35/128-06A 4101 STANFORD ST
Geare House, 35/128

STAFF ITEM

4101 Stanford Street, Chevy Chase (Geare House)

RE: 4101 Stanford

Rear elevation
approved by HPC

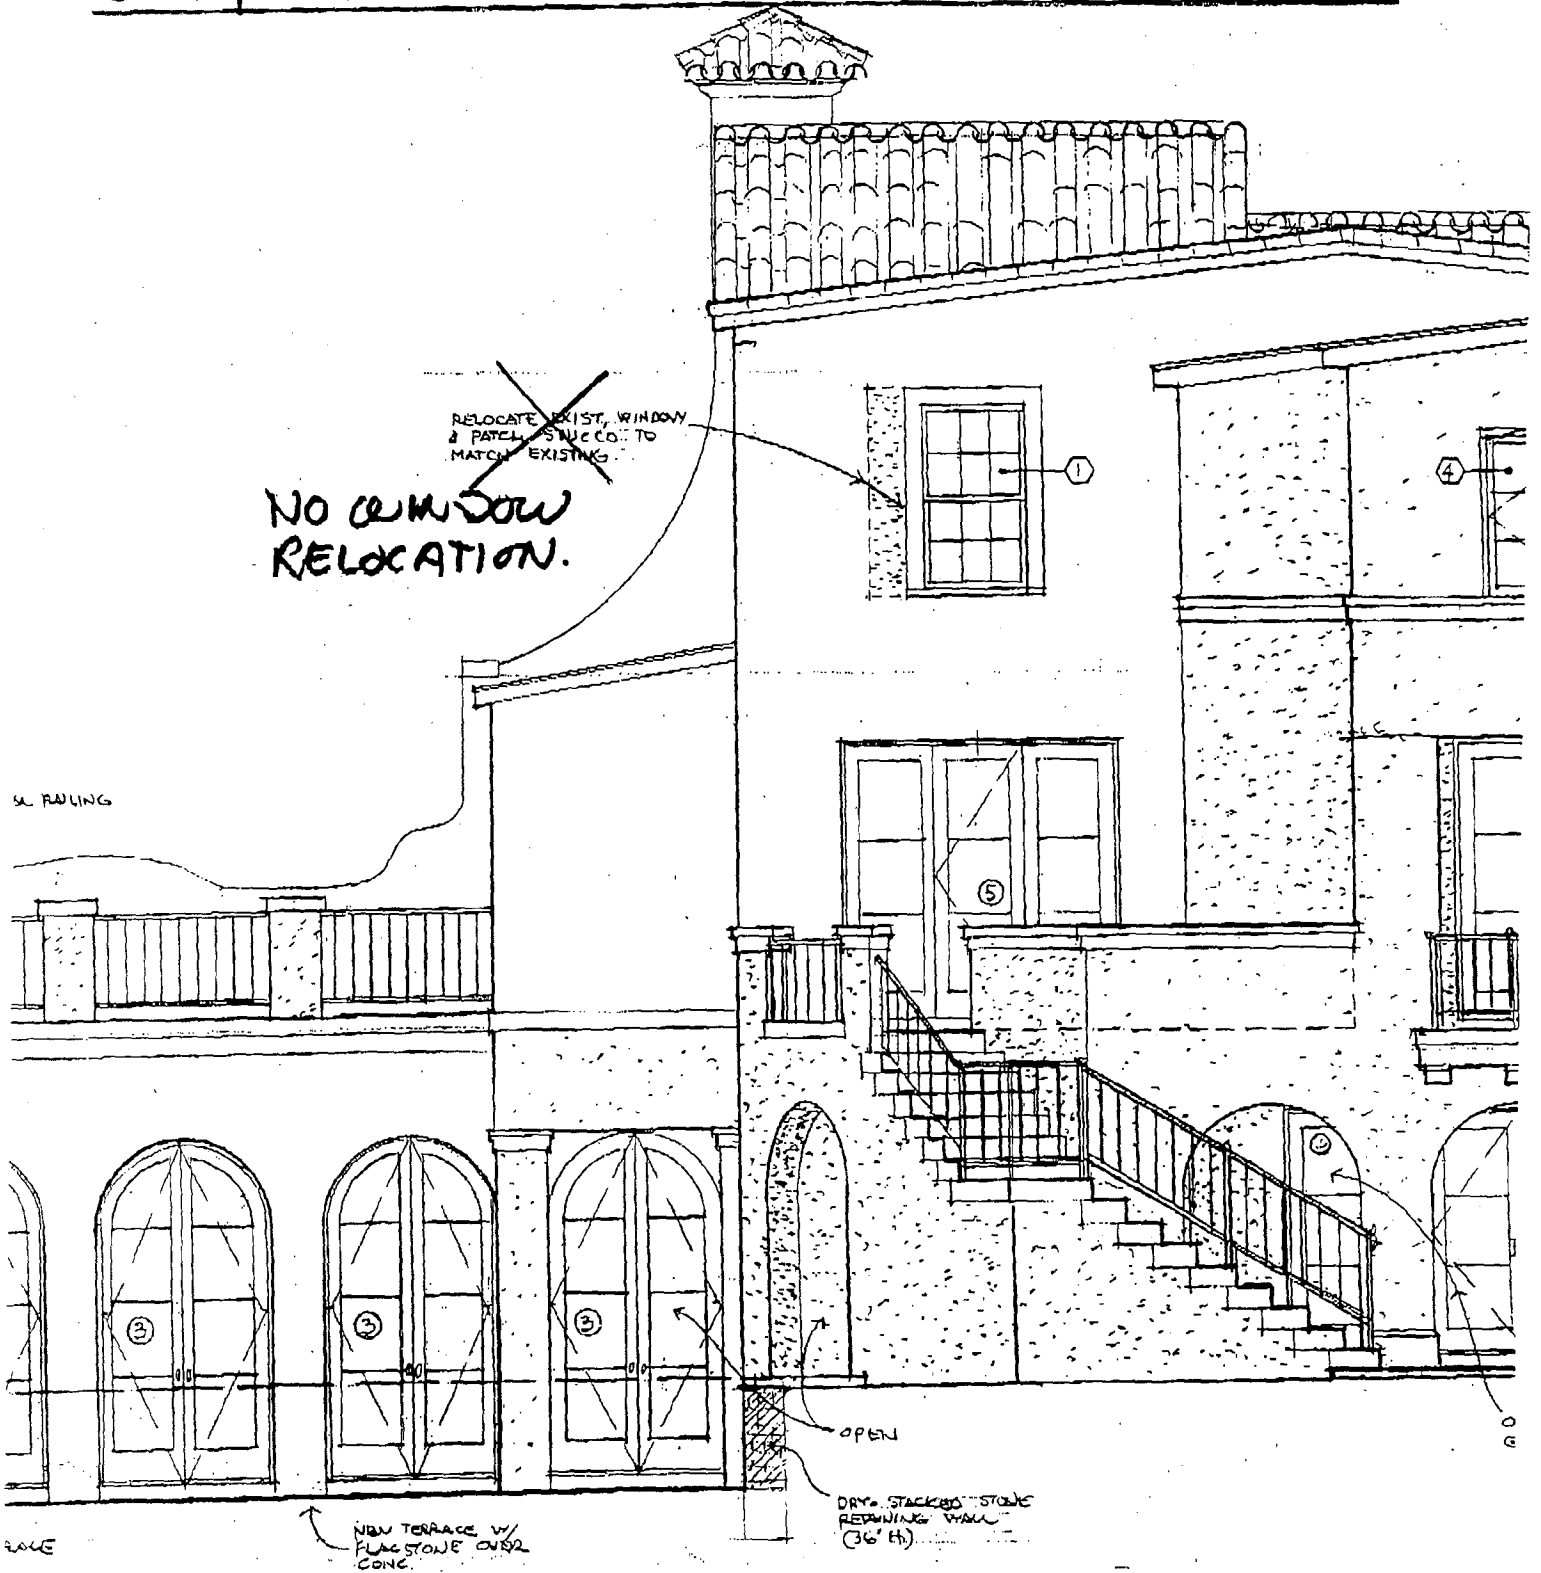
Rear Elevation:

They no longer propose to relocate the 2nd floor window.

They would like to change first floor new door from 3 unit French door to 4 unit. *circle 4*

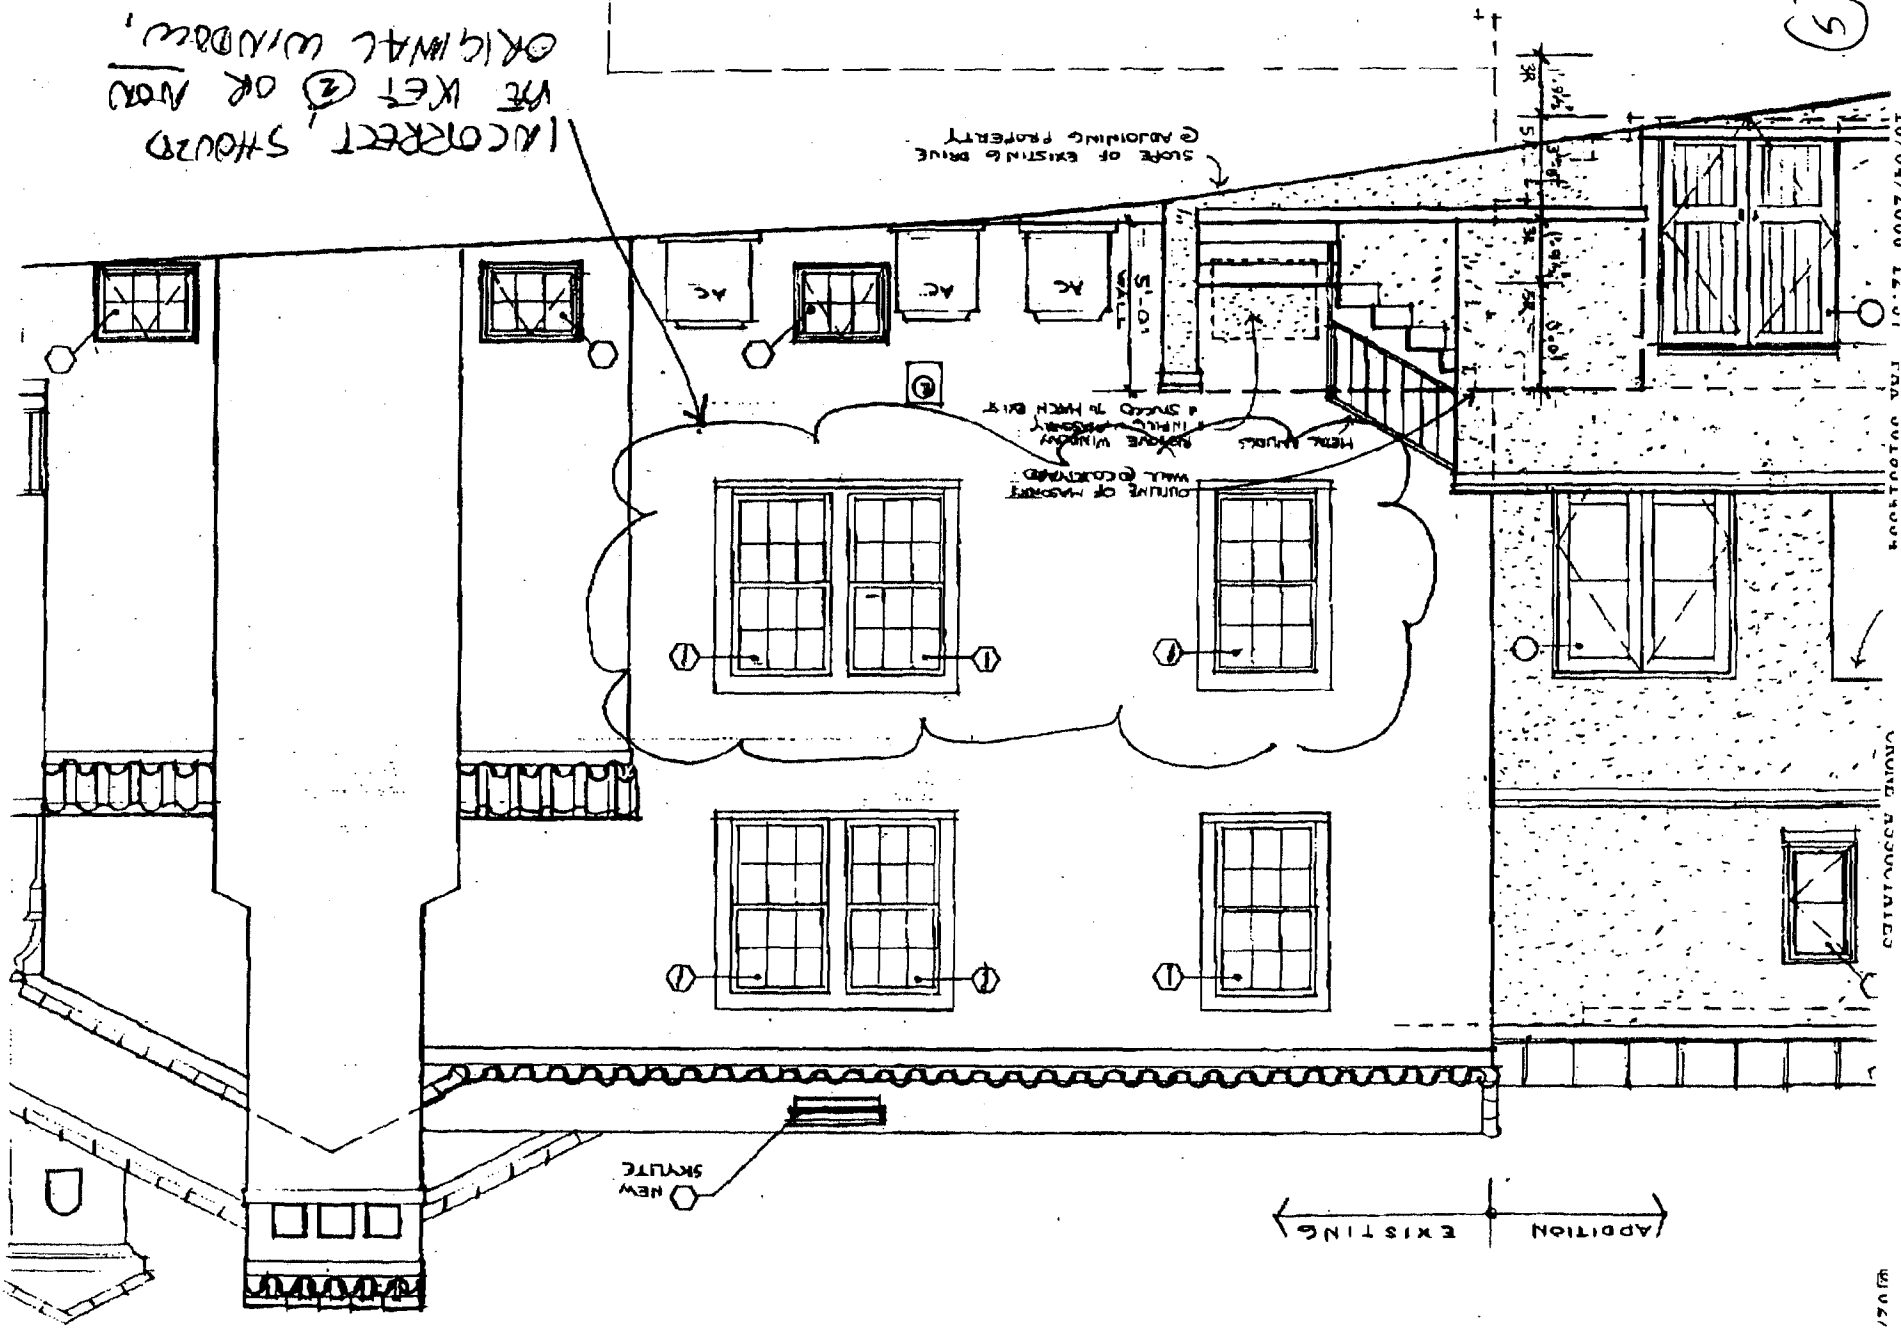
Left side Elevation:

Three windows that they had thought were original are not (snap in grills). They would like to replace these three windows with wood TDL windows to match the other original windows (two would be relocated from another part of the house where they were to be removed and one would be a new window). *circle 5*

INCORRECT, SHOULD
BE SET @ OR ABOVE
ORIGINAL WINDOWS,

REMOVE WINDOW
HERE BRACKETS
WALL GOING IN
LINE OF MASSIVE
WALL GOING IN

REMOVE WINDOW
HERE BRACKETS
WALL GOING IN

Approved
